File No. 04-1000-20-2016-466

Re: Request for Access to Records under the Freedom of Information and Protection of Privacy Act (the "Act")

1. Entire (18 page) document called Point Grey Road Sidewalk Widening Details (see attached page 17 of 18); and
2. Any reports, emails and submissions for proposed seating arrangements (benches in circles, some with bike racks as per Drawing No. 2016-20-D.L. 4.1) as part of Phase 2 construction on Point Grey Road from August 1, 2016 to November 30, 2016.

APPROVALS	INITIALS	CONTACT	REVISIONS / DESCRIPTION	INITIALS	ENGINEERING SERVICES – CITY OF VANCOUVER – TRANSPORTATION DESIGN	
	LANDSCAPE ARCHITECT					DESIGNED BY: APL	Point Grey Road Sidewalk Widening Details
	PROJECT ENGINEER					DRAFTED BY: APL	
	CONSTRUCTION COORDINATOR			ACCOUNT #:		CHECKED BY:	
	LANDSCAPE DESIGNER			DIRECTORY: H:\TRANSPORTATION_DIVISION\13-1400-30\Point Grey Road - Phase 2 (0000111)\11 - Design\landscape Design\ENG - TDE - 2016-20 - Detail Plan.dwg DATE: Aug 30, 2016 - 2:31pm USER: enapl		FILE NAME: ENG - TDE - 2016-20 - Detail Plan.dwg	
						SCALE: 1:50 DATE: August 2016 DWG. NO. 2016-20-D-L4.1 REV. NO. SHEET: 17 OF 18

Seating Area 1 - Detail Layout

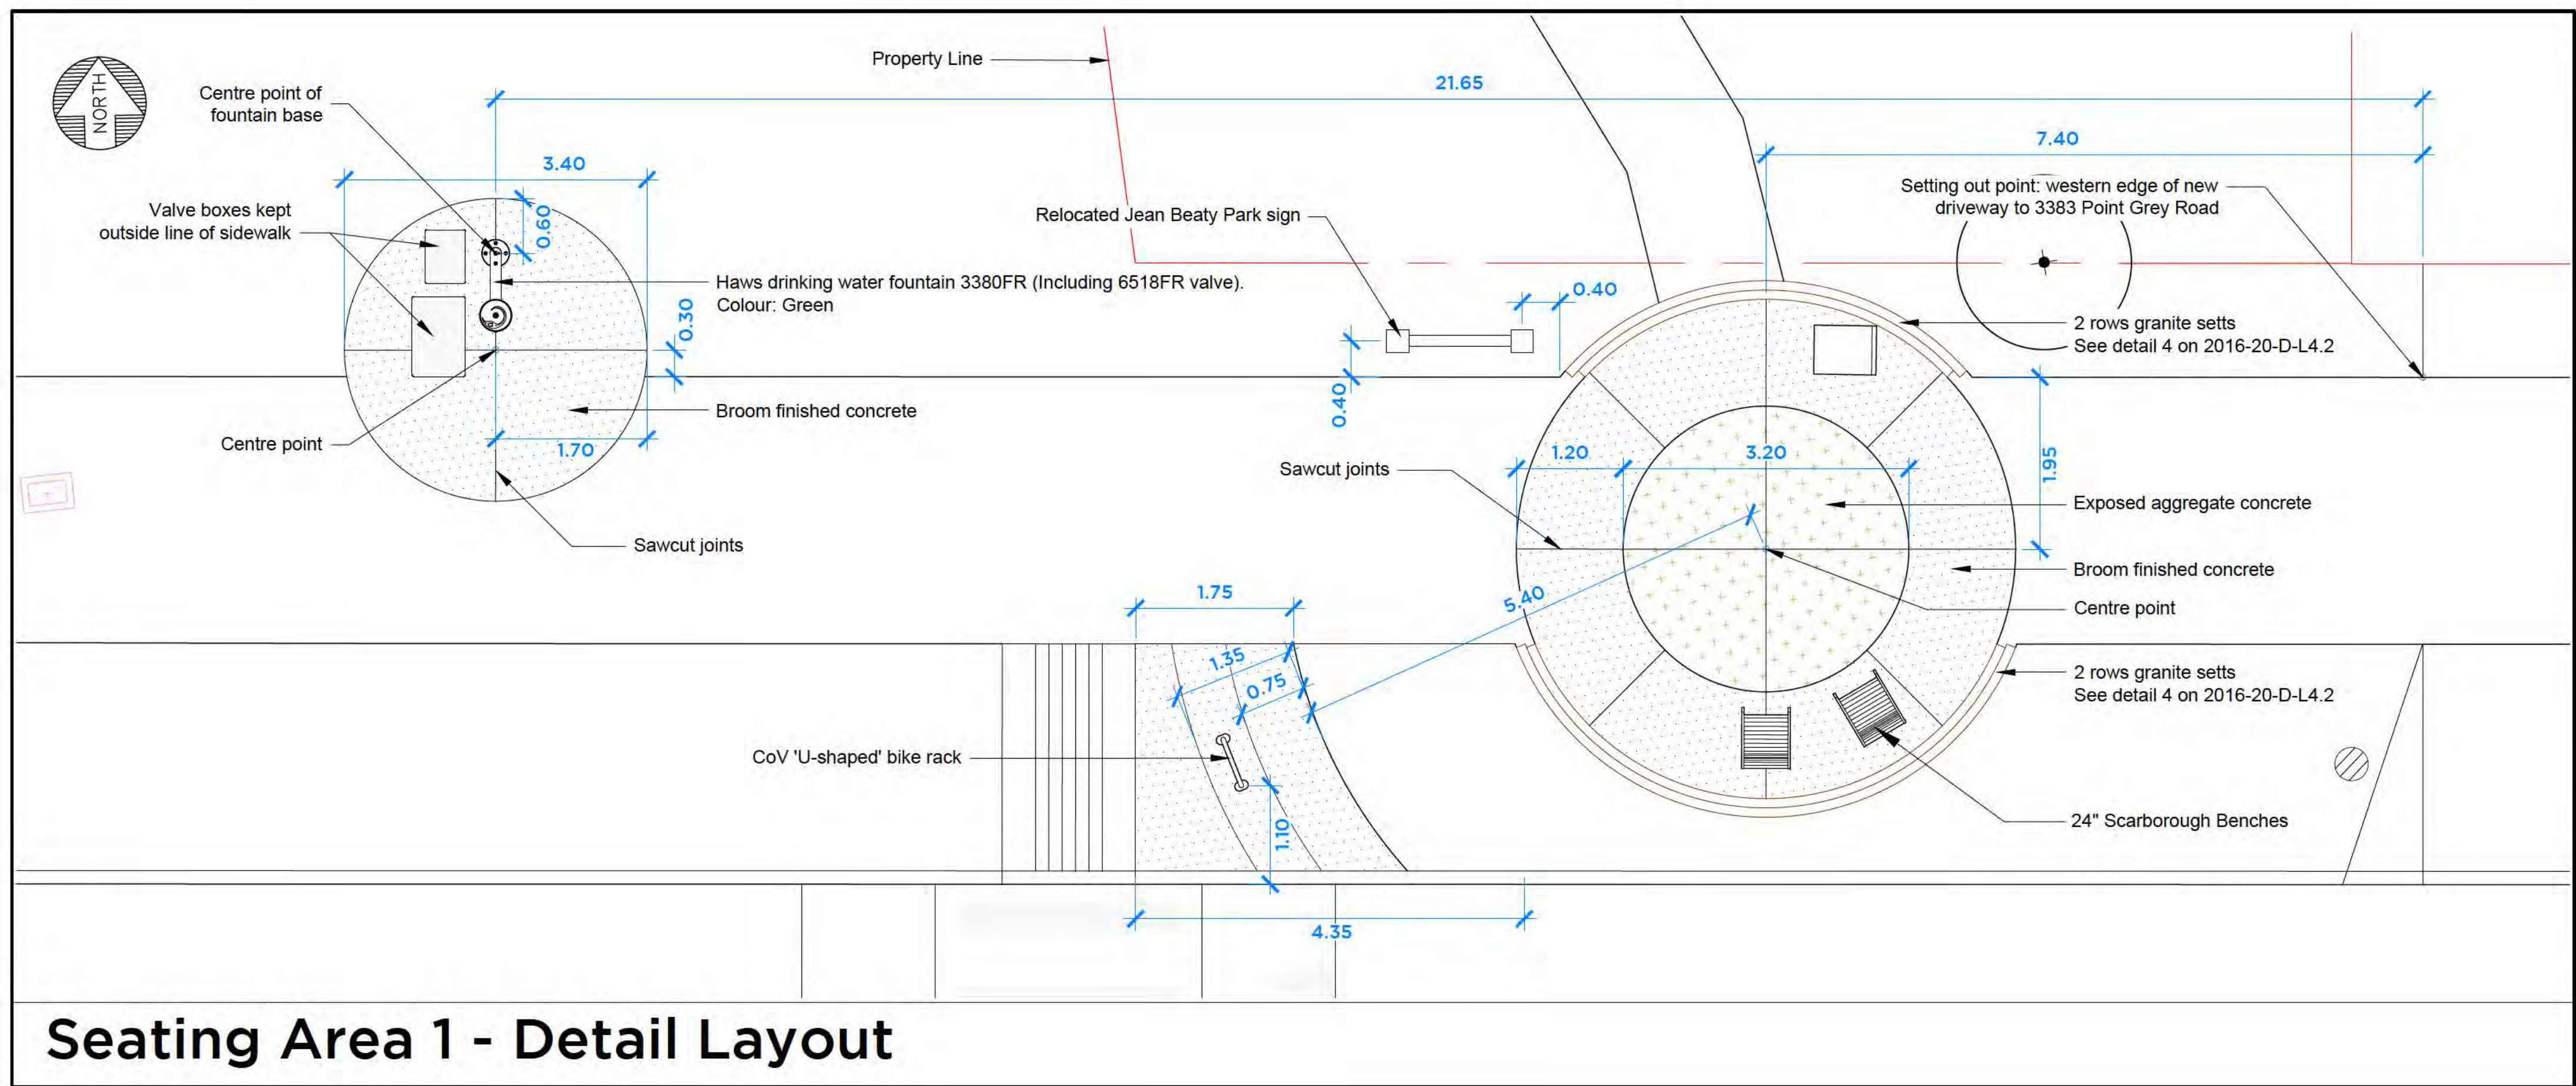
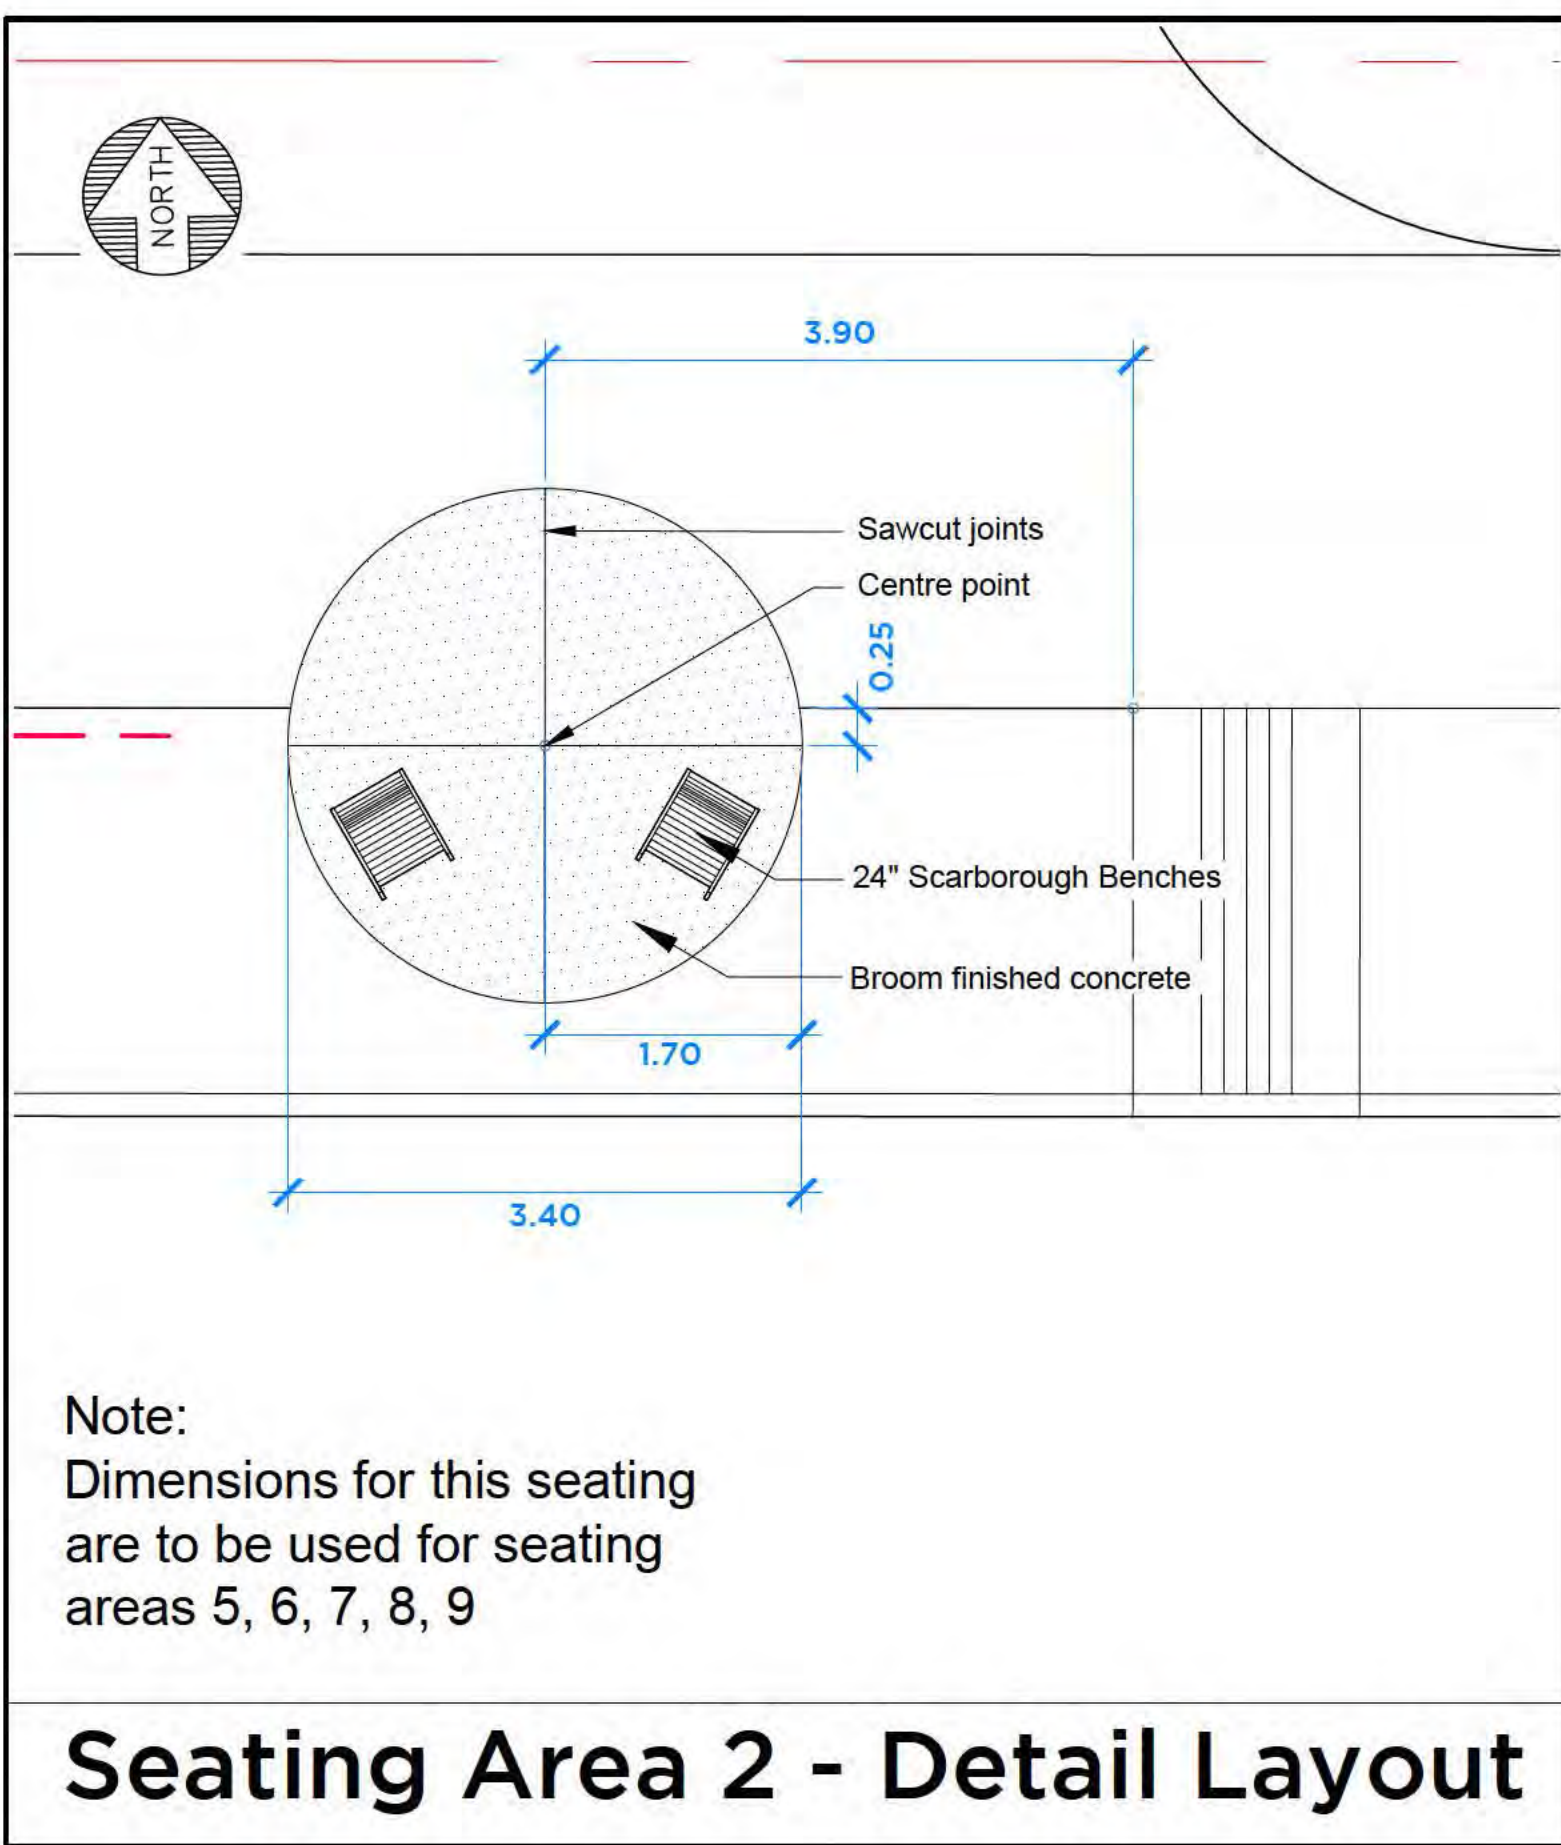
I'm not sure that will work. I've attached a PDF from Streetview showing that the park is mounded in the area of the fountain. By sloping back towards the park we may be creating a puddle at the back of the slab. May be best for it all to slope towards the street. Obviously this will not change the elevation at the centre of the slab.

Please see the attach markup of the drawing. The concrete slab should slope 1% towards the road from back of walk, and 1% towards the park (north of back of walk).

You are correct. If there are no plans to regrade the park, then we should have a constant 1% slope towards the road. We do not want to create a low point at the back of the slab.
